- NOTES TO LOCKER ROOM - REVISIONS REQUIRED BY CHANGE ORDER NO. 1 - ADDITION TO HIGH SCHOOL.
- NOTE 1 - GENERAL MECHANICAL AND ELECTRICAL CONTRACTORS: LOCKER ROOM AREAS SHALL BE CONSTRUCTED AS SHOWN ON THIS SHEET, IN LIEU OF PLAN SHEET A2.

DESIGN	JOS
DRAWN	WJE
DATE	OCT. 1979
FILE NO.	78-508
SHEET NO.	C-0-1-1

ADDITION TO HIGH SCHOOL
UNIFIED SCHOOL DISTRICT #320
WAMEGO, KANSAS

REVISION	DATE	BY
CHANGE ORDER NO. 1 REVISIONS	10/31/79	RAC

REVISED PLAN TO GYMNASIUM LOCKER ROOM AREAS TO HIGH SCHOOL ADDITION
SCALE: 1/8" = 1'-0"

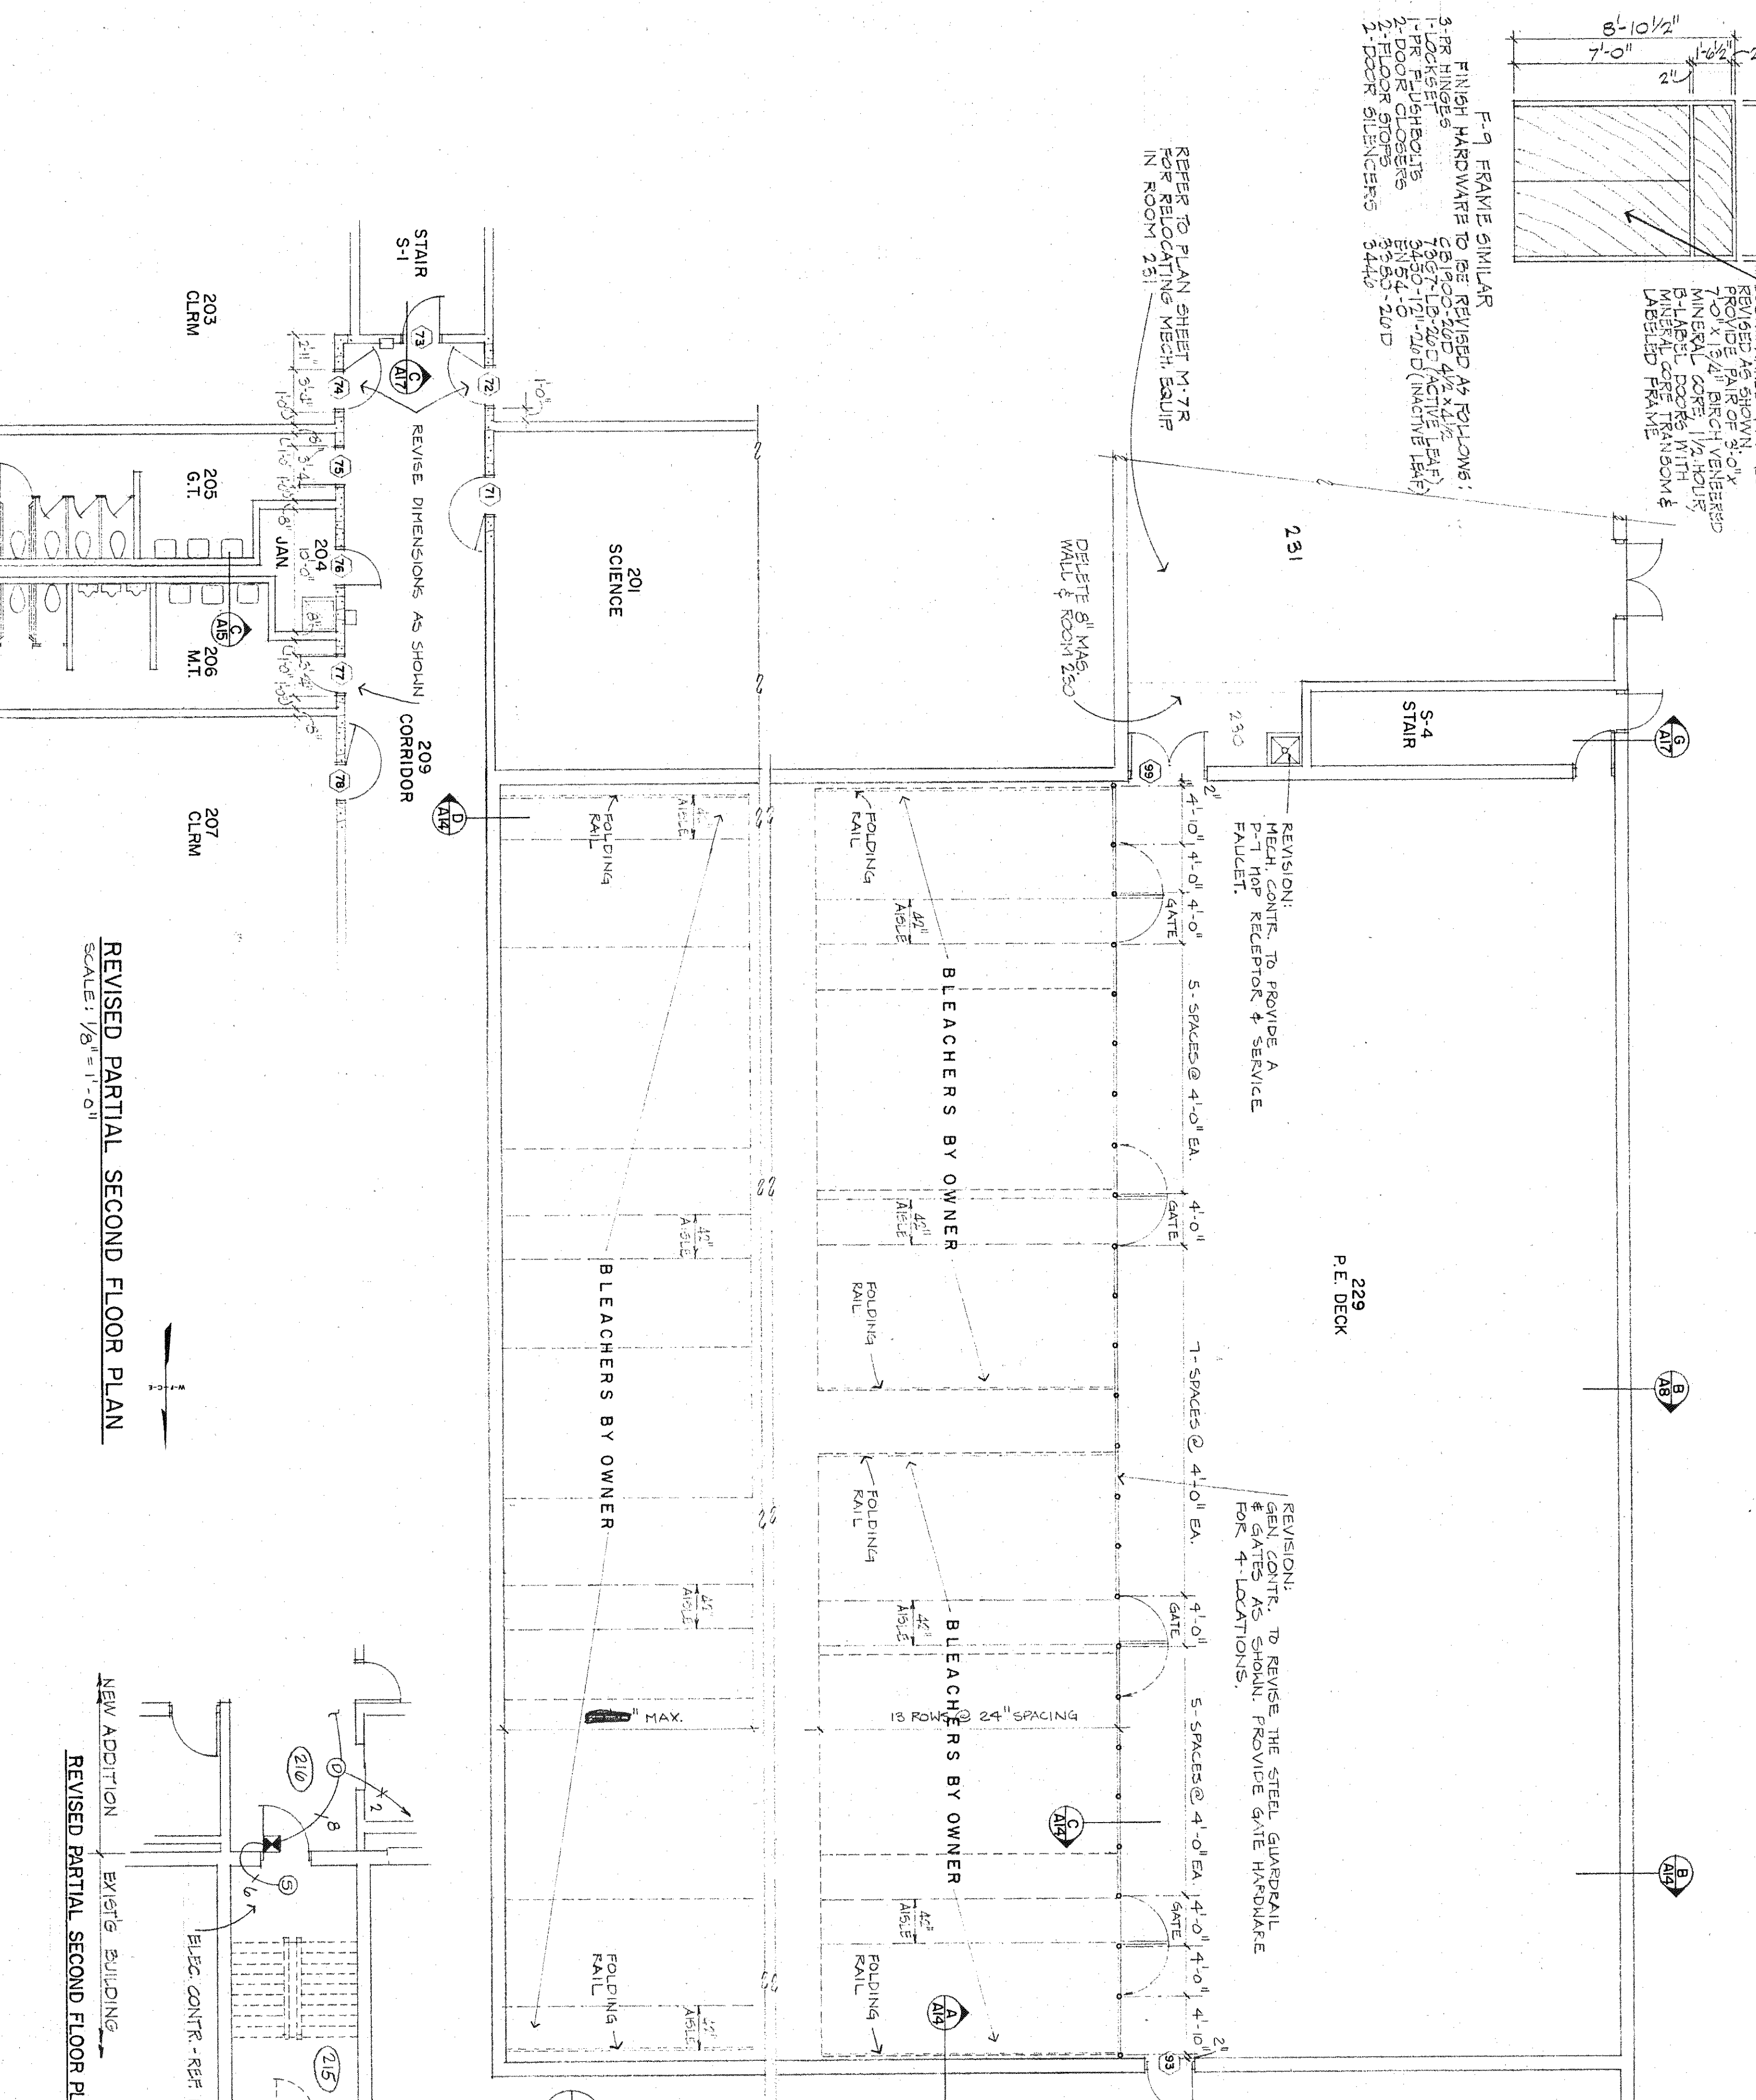
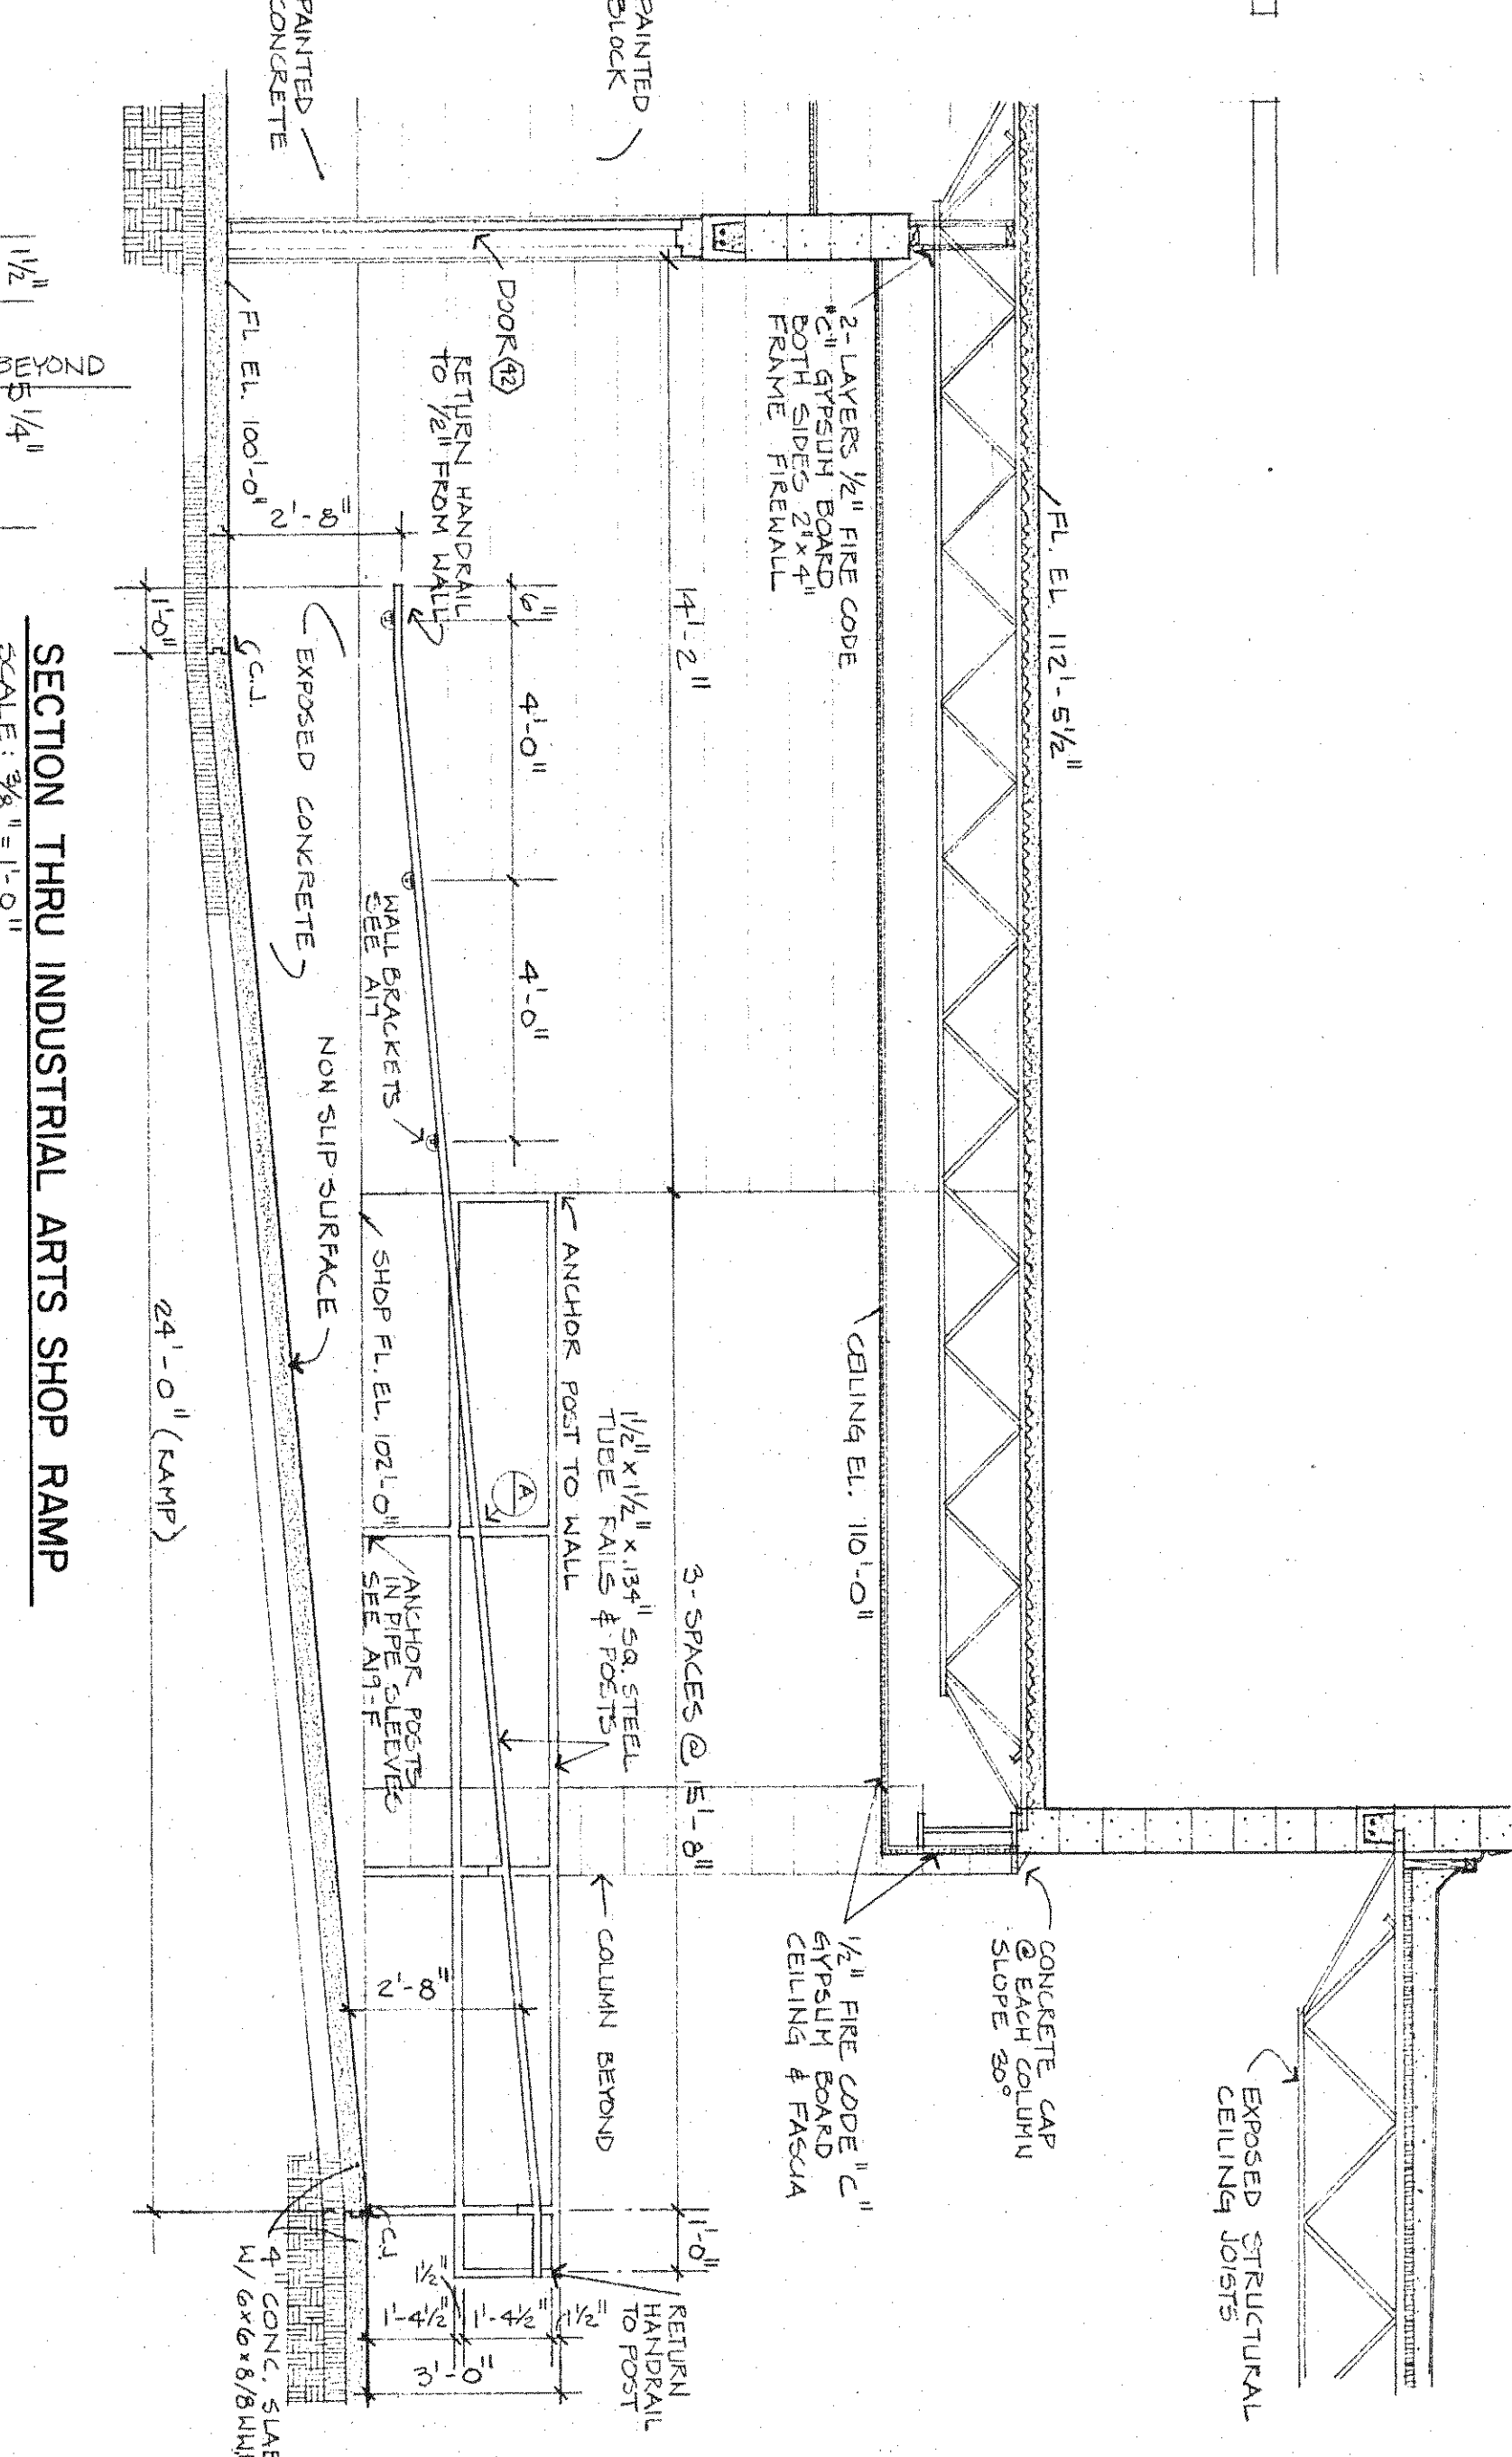
- NOTE 2 - GENERAL CONTRACTOR: PROVIDE 2'-8" WIDE METAL TOILET PARTITION DOORS SWINGING OUT TO 1'-0" PARTITION AS SHOWN IN ROOMS 145 AND 149. PROVIDE SHIMMED 2'-8" WIDE GREENS WITH 1/2" GAPS TO 1'-0" PARTITION AS SHOWN IN ROOMS 145 AND 149. PROVIDE 1/2" GAPS TO 1'-0" PARTITION AS SHOWN IN ROOMS 145 AND 149. PROVIDE 1/2" GAPS TO 1'-0" PARTITION AS SHOWN IN ROOMS 145 AND 149. PROVIDE 1/2" GAPS TO 1'-0" PARTITION AS SHOWN IN ROOMS 145 AND 149.

- NOTE 3 - GENERAL CONTRACTOR: PROVIDE P-1 WATER CLOSERS, WHERE SHOWN IN LIEU OF P-1 WATER CLOSERS, PROVIDE P-1 WATER CLOSERS, WHERE SHOWN IN LIEU OF P-1 WATER CLOSERS, PROVIDE P-1 WATER CLOSERS, WHERE SHOWN IN LIEU OF P-1 WATER CLOSERS.

- NOTE 4 - GENERAL CONTRACTOR: PROVIDE P-3 LAVATORIES IN LIEU OF THE P-3 LAVATORIES SPECIFIED. PROVIDE P-3 LAVATORIES IN LIEU OF THE P-3 LAVATORIES SPECIFIED. PROVIDE P-3 LAVATORIES IN LIEU OF THE P-3 LAVATORIES SPECIFIED.

- NOTE 5 - GENERAL CONTRACTOR: SEE PLAN DIMENSION FOR REVISION LENGTH TO WIRE MESH PARTITION.
 - NOTE 6 - ELEC. CONTRACTOR: PROVIDE A TOTAL OF 5 NEW EXTINGUISHERS, DELETE 1 - EXISTING EXTINGUISHER AS SHOWN ON THIS SHEET. PROVIDE CONNECTION FOR SMOKE DETECTOR AND DOOR RELEASE AT DOOR 101-10 AT JUNCTION BOX IN CORRIDOR 101-A. PROVIDE SMOKE DETECTOR AND CONNECTION TO DOOR RELEASE AT DOOR 101-10 AT JUNCTION BOX IN CORRIDOR 101-A. PROVIDE SMOKE DETECTOR AND CONNECTION TO DOOR RELEASE AT DOOR 101-10 AT JUNCTION BOX IN CORRIDOR 101-A.

- NOTE 7 - GENERAL CONTRACTOR TO PROVIDE, ABOVE EACH HANDICAP LAVATORY A 5"x24" STAINLESS STEEL SHELF, OR EQUAL, UNDER MIRROR AT 40" FROM FLOOR. SHELVES AS MANUFACTURED BY BOBRIX, NO. B-295.

- NOTE 8 - SHEET A-5, ROOM FINISH SCHEDULE: ALL GYPSUM BOARD CEILINGS ARE TO BE 1/2" FIRECODE "C" OR EQUAL.
 - NOTE 9 - SHEET A-5, ROOM FINISH SCHEDULE: ALL GYPSUM BOARD CEILINGS ARE TO BE 1/2" FIRECODE "C" OR EQUAL.
